REQUEST

Current Zoning: R-3 (single family residential)
Proposed Zoning: UR-2(CD) (urban residential, conditional)

Approximately 5.12 acres located on the southeast side of Carmel Rd, north of Carmel Vista Ln. and south of Quail View Rd.

PLANNING STAFF REVIEW

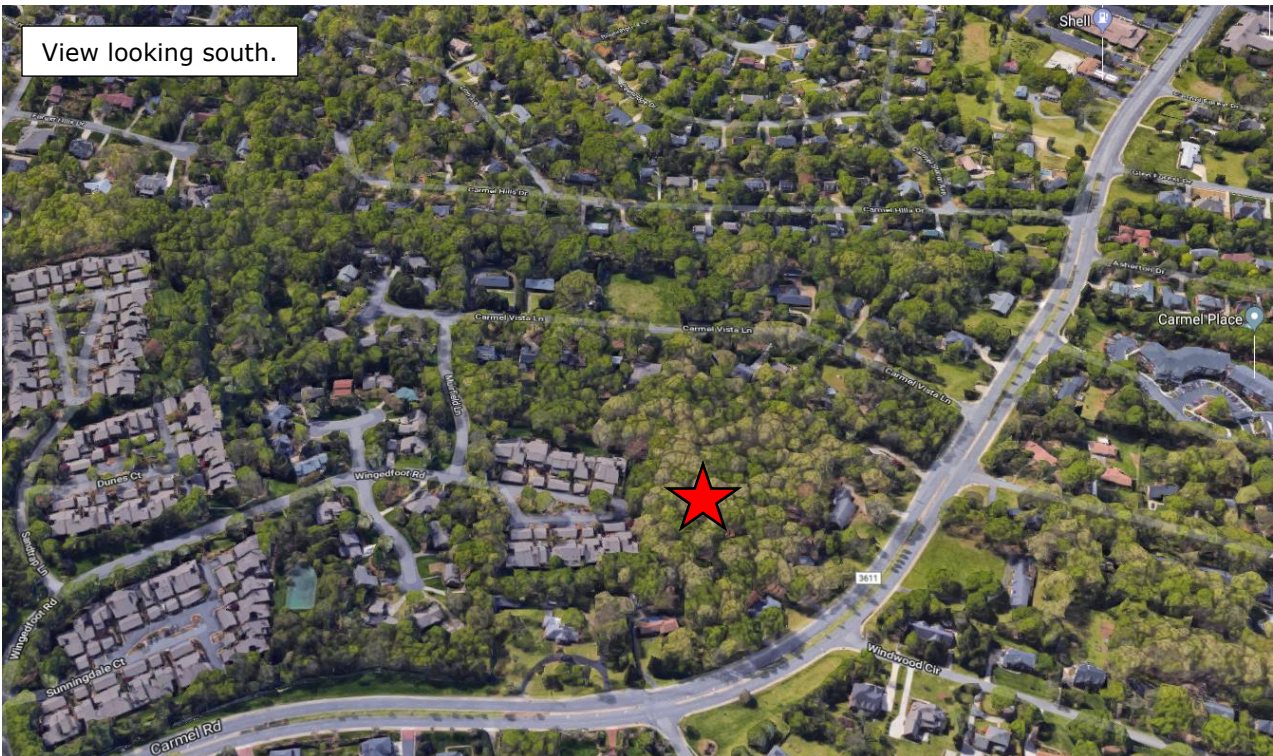
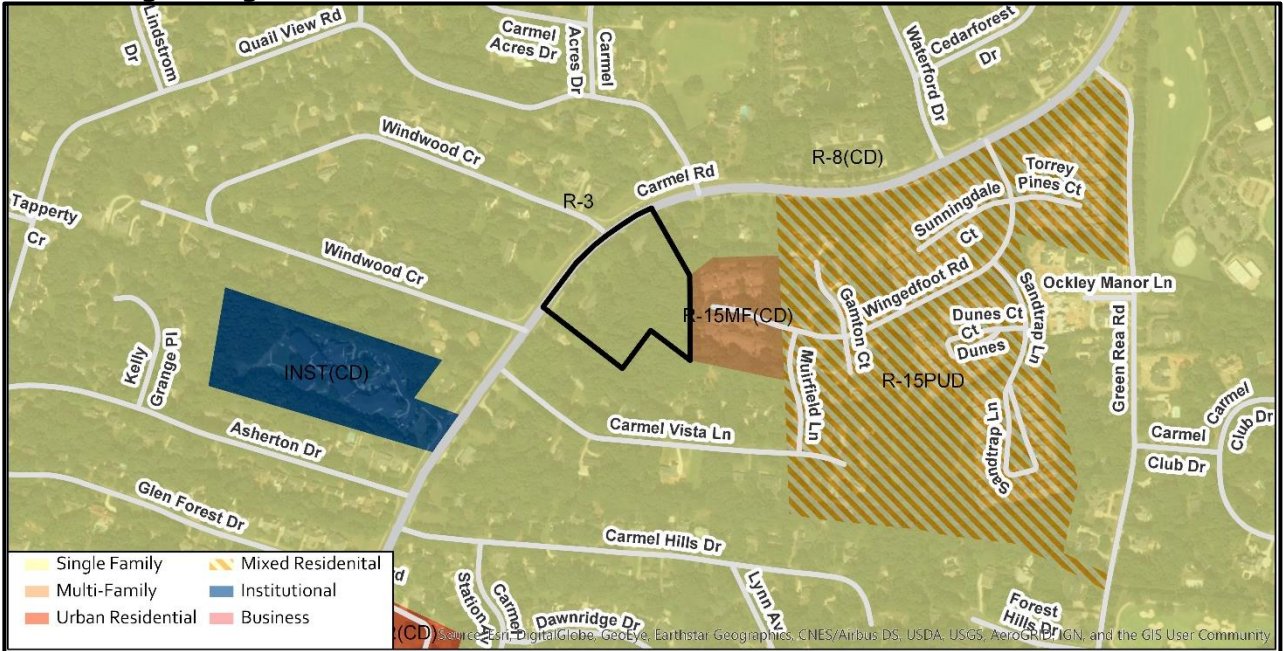
1. ~~Provide a minimum distance between the proposed building 4 and the property line.~~ Addressed

2. ~~Specify that the dedication of ROW, planting strip and sidewalk shall be completed prior to the first certificate of occupancy for the first new building on the site.~~ Addressed

3. ~~Remove reference to "wall pack" lighting in notes.~~ Addressed

4. ~~Under note "a" of Environmental Features revise *Post Construction Controls Ordinance* to read *Post Construction Stormwater Ordinance*.~~ Addressed
5. ~~Add the following note under the ENVIRONMENTAL FEATURES heading: "*For adjoining parcels receiving storm water discharge from the site, the petitioner shall analyze the adequacy of the existing storm water conveyance on the adjoining parcels to and including Carmel Vista Lane. If the existing storm water conveyance on the adjoining parcels is found to be inadequate, the Petitioner shall make a good faith effort with the property owner(s) to improve the storm water conveyance or mitigate the storm water discharge onto the adjoining parcels.*"~~ Addressed
